UDO Advisory Committee

FEBRUARY 22, 2024

Potential Changes to UDO Standards for UAC Discussion

Maximum Driveway Width Crossing Sidewalk Potential New Standard #1

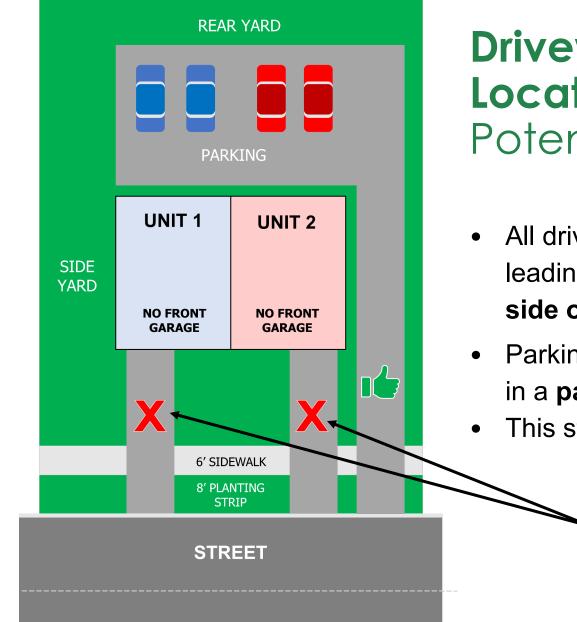
- Driveway width **shall not exceed 12 feet** between the back of curb/street edge and five feet behind the back of sidewalk or ROW, whichever is greater.
- This standard would **minimize conflict** between vehicles and pedestrians.

If no sidewalk, measurement taken from ROW

Driveway and Parking Location Potential New Standard #2

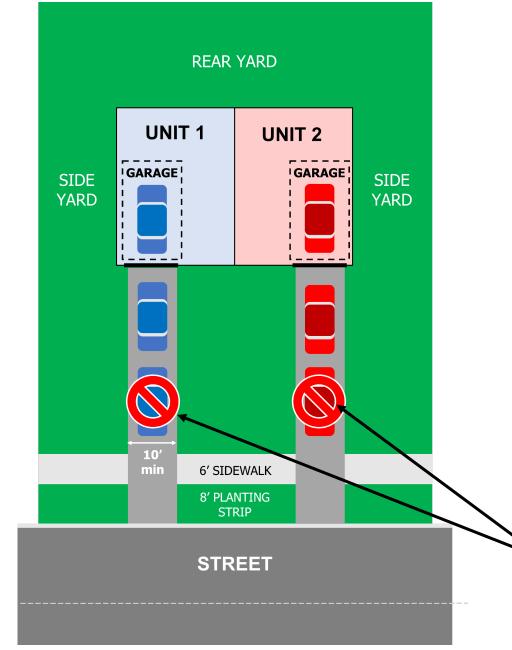
- All driveways/parking, other than a driveway leading to a street-facing garage, must be to the side or rear of building.
- Parking spaces shall be located on a driveway, in a parking lot, or in a garage.
- This standard would limit "front yard" parking

These driveways not allowed if no front-facing garages

Driveway Parking Potential New Standard #3

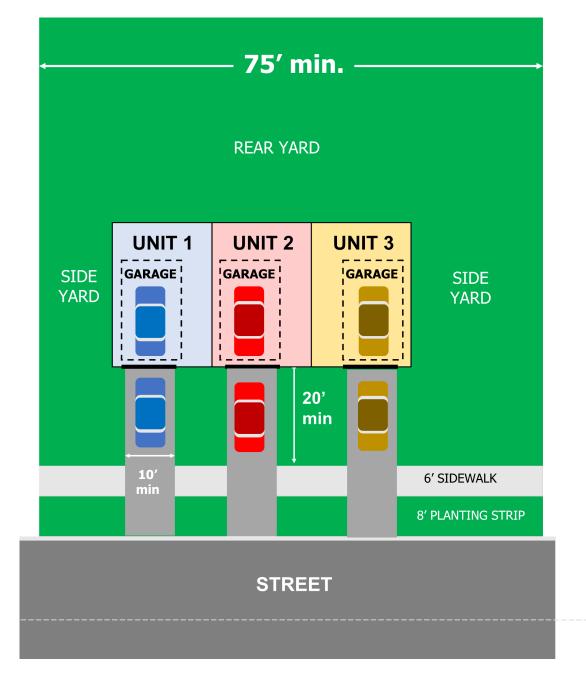
- Parking on driveways going to front-facing garages may not count for more than one required parking space.
- This standard would discourage pushing building back to create long driveway to meet parking requirement.

Does not count toward required minimum

75'+ Lot Width Potential New Standard #4

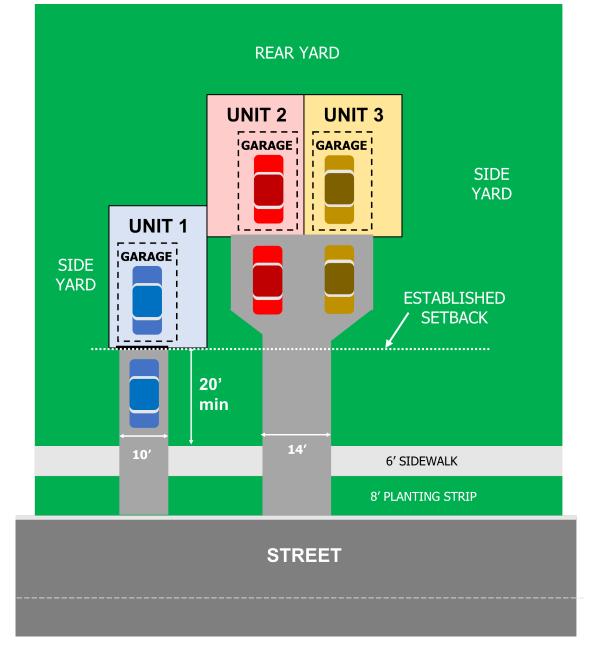
- Increase maximum cumulative width from 24' to 30' for lots of 75' or more in width.
- This standard would provide more flexible driveway standards.

Widened Driveway beyond Established Setback Line Potential New Standard #5

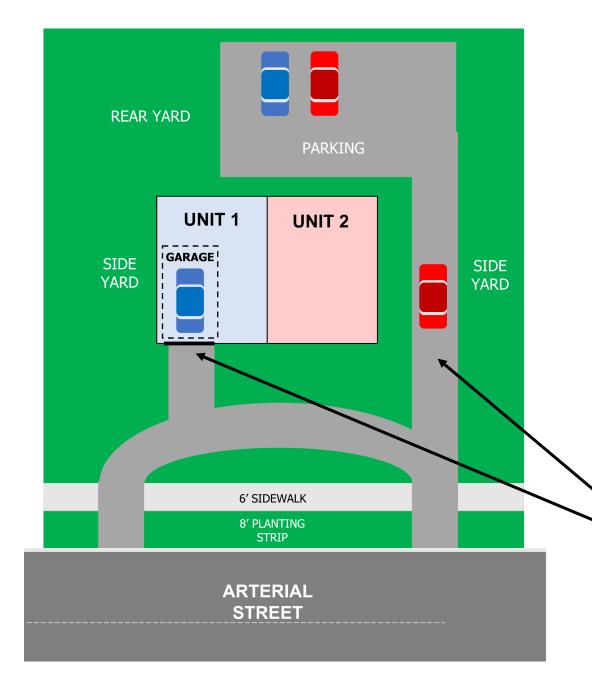
- Allow driveway to widen when beyond established setback line set by one triplex unit.
- This standard would provide more flexibility for triplexes.
